**Chatfield Farms II  
Active Adult Community  
Beacon Falls, Connecticut**

**King's Mark  
Environmental Review Team Report**

**June 2006/July 2006**

**Report #338**

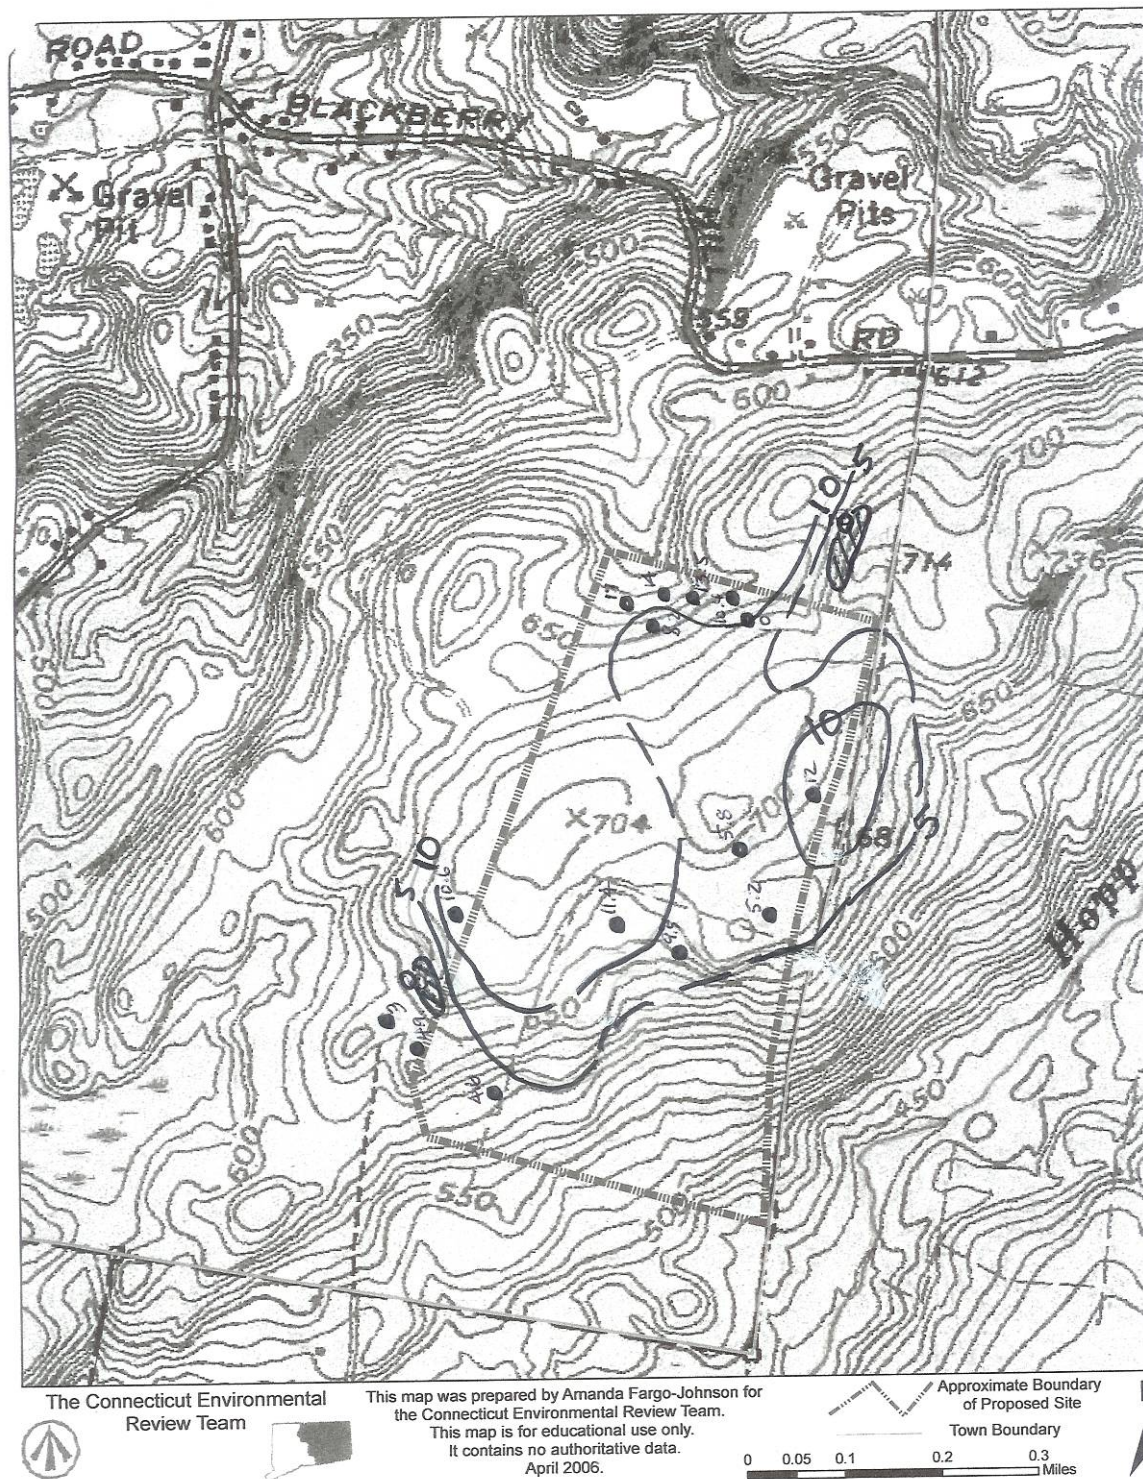
Notable is the very thin soil across the area. Figure 6 is a map showing an interpretation of the soil thinness on the parcel based on test-holes dug by the applicant. This interpretation is reinforced by field observations (Figures 4 and 5) of many areas with angular exfoliated gneiss slabs that are not far from the outcrop. Flint (1978) shows the entire parcel covered by a thin (10' or less in thickness) veneer of till that was deposited by glaciers during the last Ice Age.

Thin soils will pose a problem to development. In some areas blasting may be needed for basements and to adequately bury utilities. Fill may need to be imported to build up adequate road beds.

**Figure 2** Maximum Recommended Development Area to Maintain Healthy Wetlands Function

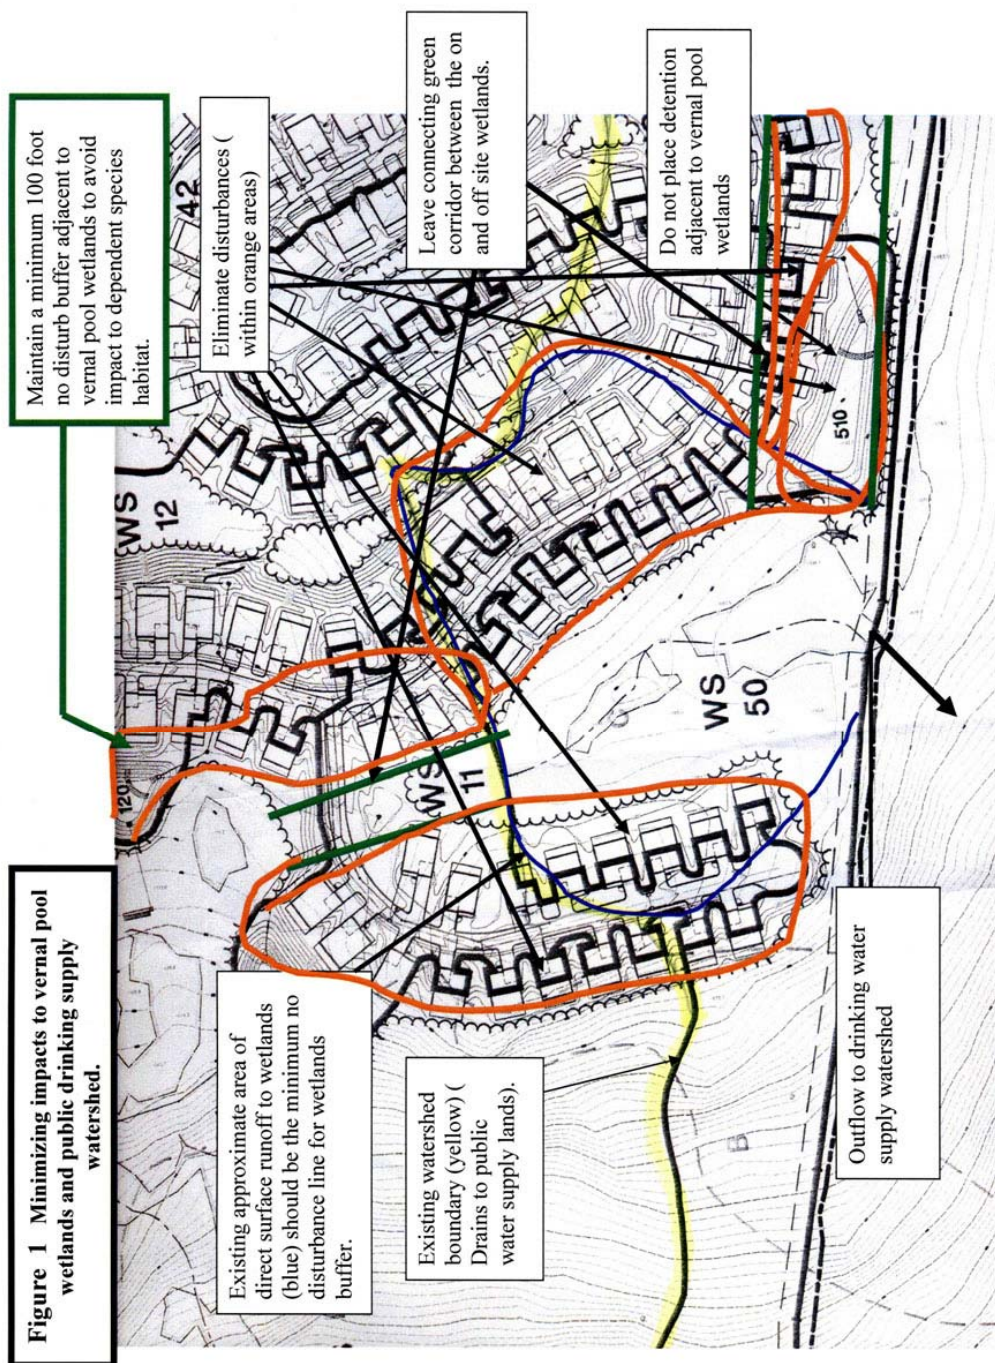
**Figure 1** demonstrates recommendations for protecting the vernal pool wetlands known as WC & WD. The blue line indicates the approximate surface drainage area contributing to the wetlands under current conditions based on the USGS Quadrangle map. This area should be left undisturbed to provide a minimum buffer and habitat for dependant vernal pool species. A minimum of 100 feet surrounding a vernal pool is required to maintain its functioning. Further, only a maximum of 25% of the 750 envelop around a vernal pool should be utilized for development. No Stormwater control structures such as detention basins should be located within the 750-foot area. Connectivity between wetlands and between wetlands and uplands is necessary for amphibians and wetland dependant bird species ( Buffer Zones and Beyond page26).With these considerations in mind for this as well as the other wetland areas, a development “envelope” as indicated in **Figure 2** is derived.

It should be noted that leaving a conservation envelope as indicated in **Figure 2**, although it leaves a relatively intact interconnectivity between wetland/vernal pool areas, it does not necessarily leave intact upland areas sufficient for the maintenance of certain wetland plant and animal species nor does it necessarily meet the criteria for vernal pool buffers as evidenced by Calhoun and Klemens and others. For example, Wood Frogs and Spotted Salamanders are species particularly sensitive to loss of interior forested habitat (Wetland Buffer Zones and Beyond page 23). An arbitrary buffer line, even one at 750 feet, may not be as effective as disturbing some areas within 750 feet in order to leave intact particular habitat farther away than 750 feet. Examination of wetland buffer criteria is particularly important when evaluating the optimum placement of detention basins and other Stormwater control structures that can have a significant detrimental impact on wildlife when located within the 750 buffer of vernal pool wetlands. The wetlands investigation ( Wetland Delineation Report Chatfield Farms II Beacon Falls Ct. March 1, 2006) included with the proposal is a thorough identification of the wetlands and their general functions but in order to determine a more effective conservation area boundary, a thorough scientific assessment ( including sampling ) of the wetlands and associated habitats should be undertaken. An assessment should also take into consideration nearby offsite wetland areas and associated habitats.

No Disturbance Area

No Disturbance Area will Maintain connectivity between wetlands while leaving some essential uplands intact. Maintain the minimum 100 foot no disturbance buffer around vernal pools and minimize fragmentation and impacts on hydrology.

**FIGURE 3**

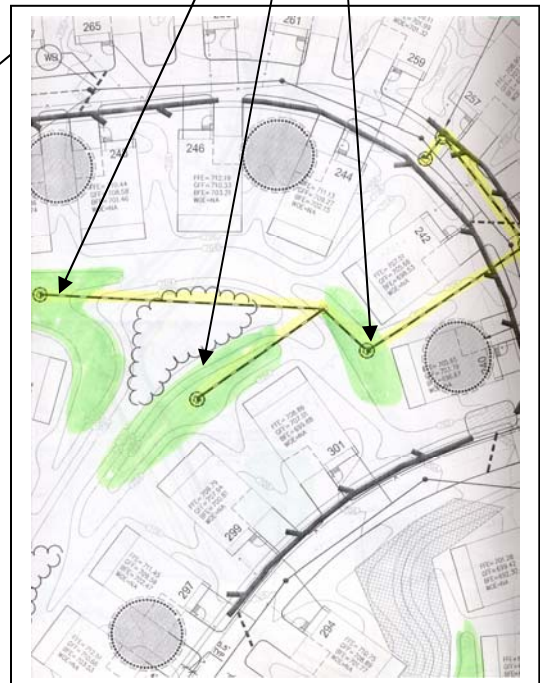
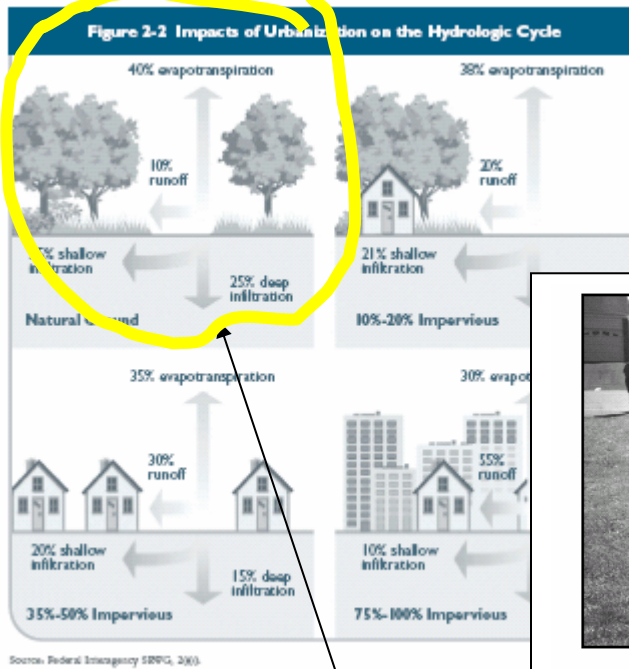
The first step is to leave as much of the existing hydrology intact as is possible (see **Figure 2**). The second step is to retain Stormwater as close to the source as possible. **Figure 3** demonstrates a possible means of retaining Stormwater closer to the source(s). Rather than convey Stormwater via yard drains, drainage from the yard area and roof runoff could be retained in a vegetated swale/basin with a controlled outlet. Another

Instead of yard drains create rain gardens or bioretention areas with controlled outlets/ infiltration for native vegetation uptake/ retention of yard and roof drainage.
